ORIGINATION FORM

Proposed Revisions to a Standard Plans Index

Index Number: 700-041

Index Title: Span Sign Structure

LAST REVISION	11/01/22	DESCRIPTION:		FY 2022-23 STANDARD PLANS	SPAN SIGN STRUCTURE	INDEX 700-041	SHEET 1 of 5
---------------	----------	--------------	--	------------------------------	---------------------	------------------	-----------------

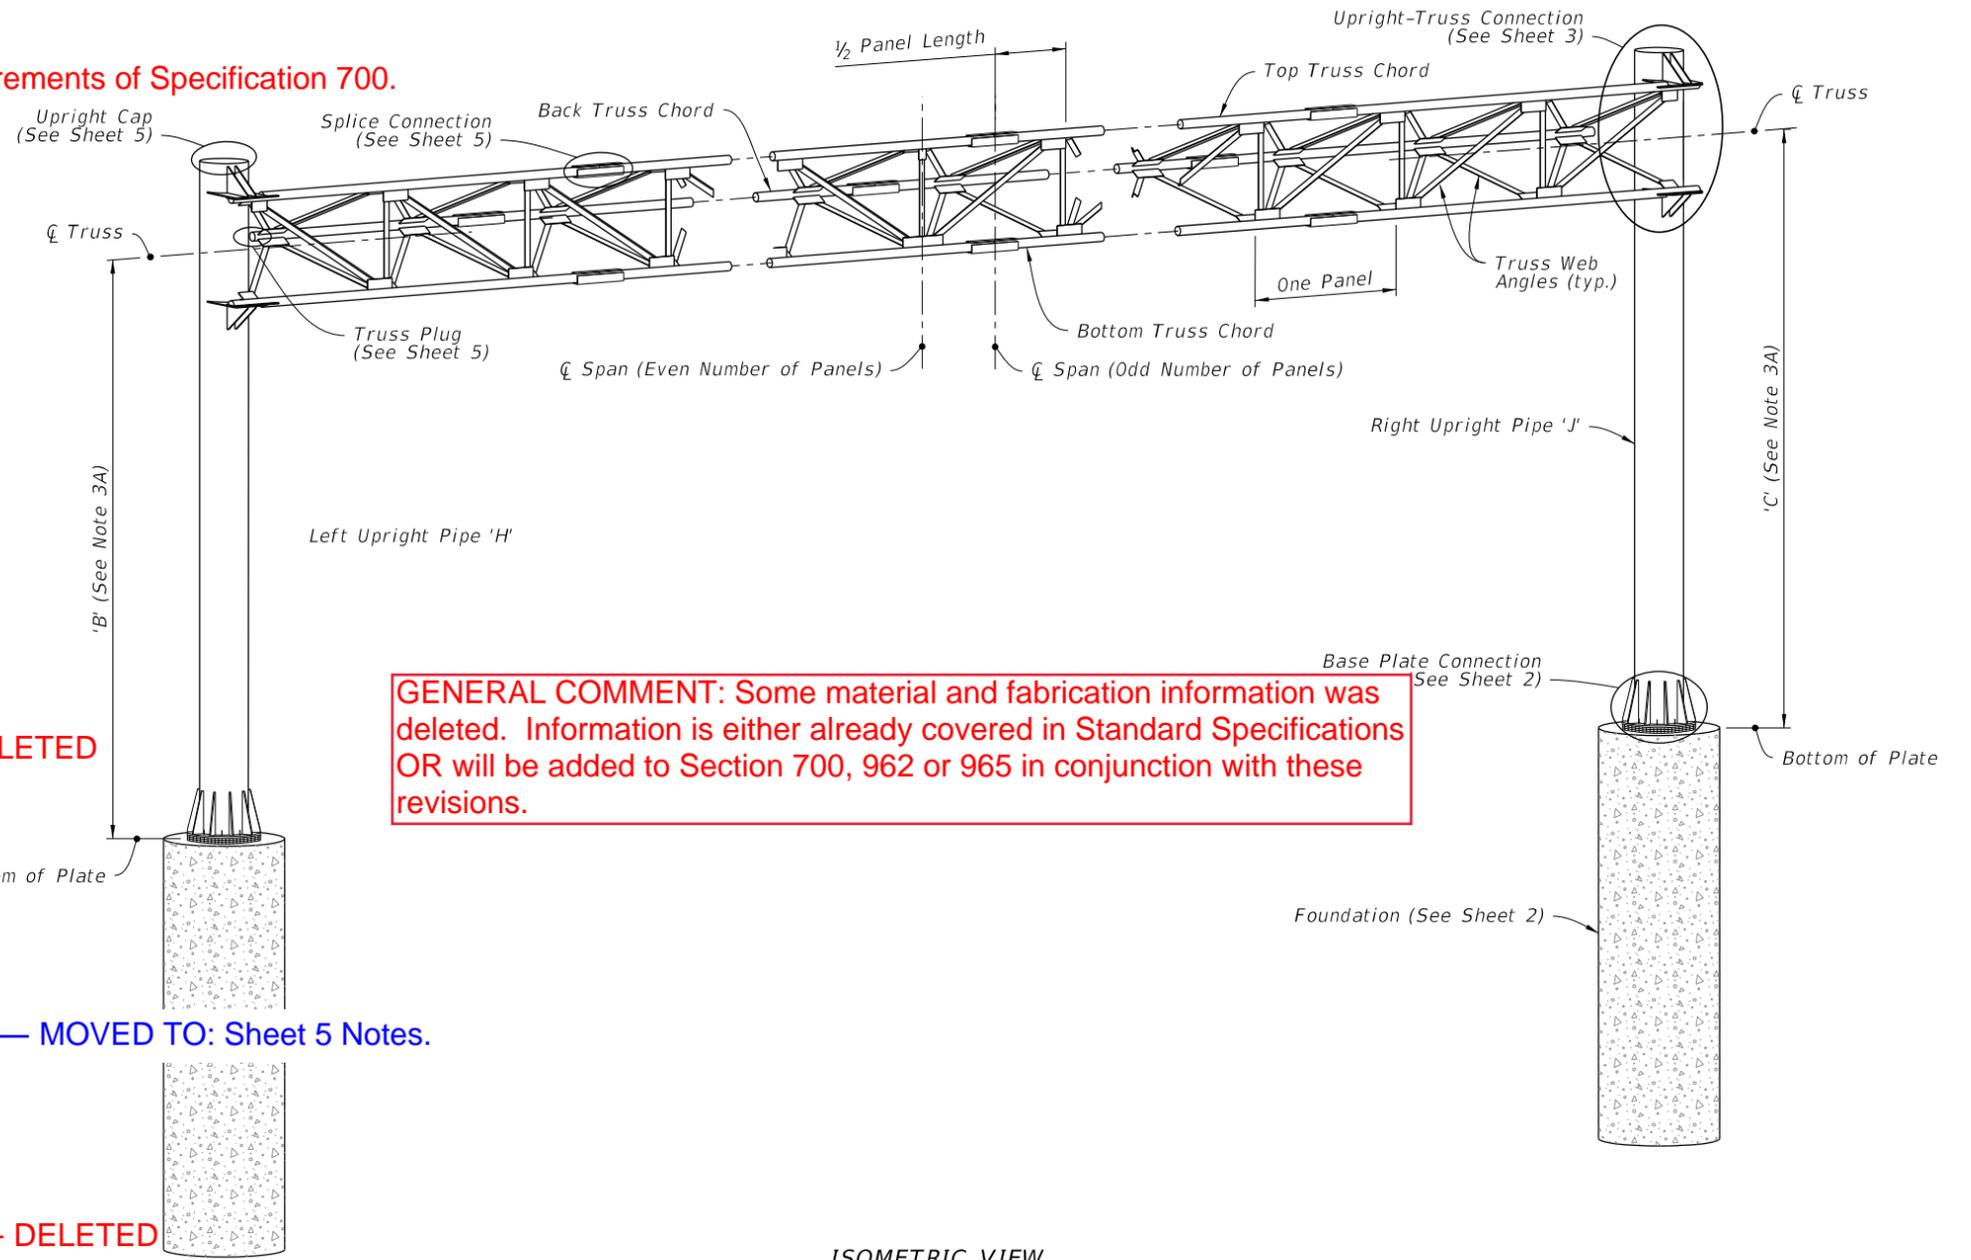
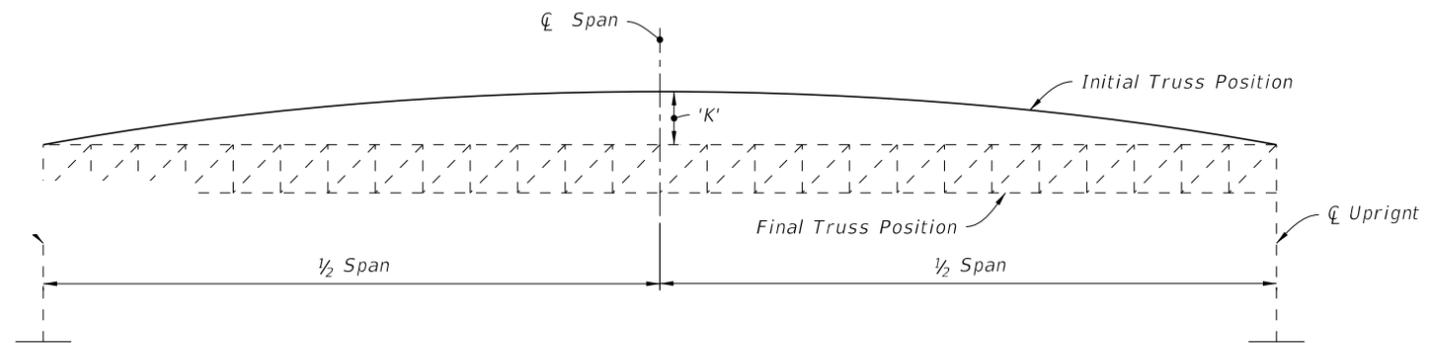
Sheet 1: Updated Notes to General Notes; Added New General Note 1 - "Meet the requirements of Specification 700"; Deleted Notes 4 through 7; Moved Note 5.B and 5.C to Sheet 5 Notes; Renumbered Notes.

ADDED NEW NOTE 1: Meet the requirements of Specification 700.

UPDATED: GENERAL NOTES:

GENERAL COMMENT: Some material and fabrication information was deleted. Information is either already covered in Standard Specifications OR will be added to Section 700, 962 or 965 in conjunction with these revisions.

DELETED

MOVED TO: Sheet 5 Notes.

DELETED

DELETED

SHEET
5 of 5

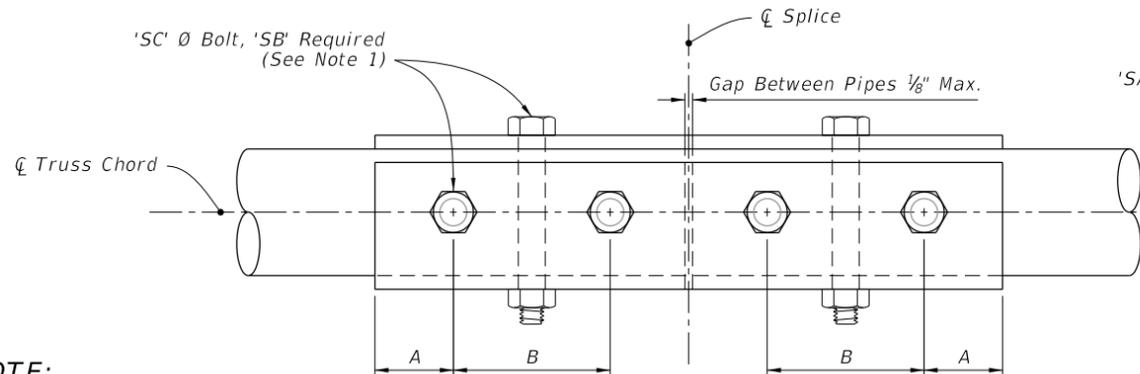
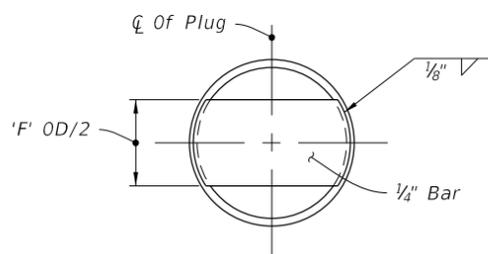
Sheet 5: Added General Note 5.B and 5.C as New Note 2 - "Chord Splices: Minimum splice spacing is three truss panel lengths apart and three truss panel lengths from the uprights when panel lengths are 10'-0" or less. Chord Splices may be either the Standard Splice or the Alternate Splice, but not both on the same structure." and Note 3 - "Upright splice: Not allowed unless the upright exceeds available mill lengths (35' - 40')."

ADDED NOTES 2 AND 3:

- 2. Chord Splices: Minimum splice spacing is three truss panel lengths apart and three truss panel lengths from the uprights when panel lengths are 10'-0" or less. Chord Splices may be either the Standard Splice or the Alternate Splice, but not both on the same structure.
- 3. Upright splice: Not allowed unless the upright exceeds available mill lengths (35' - 40').
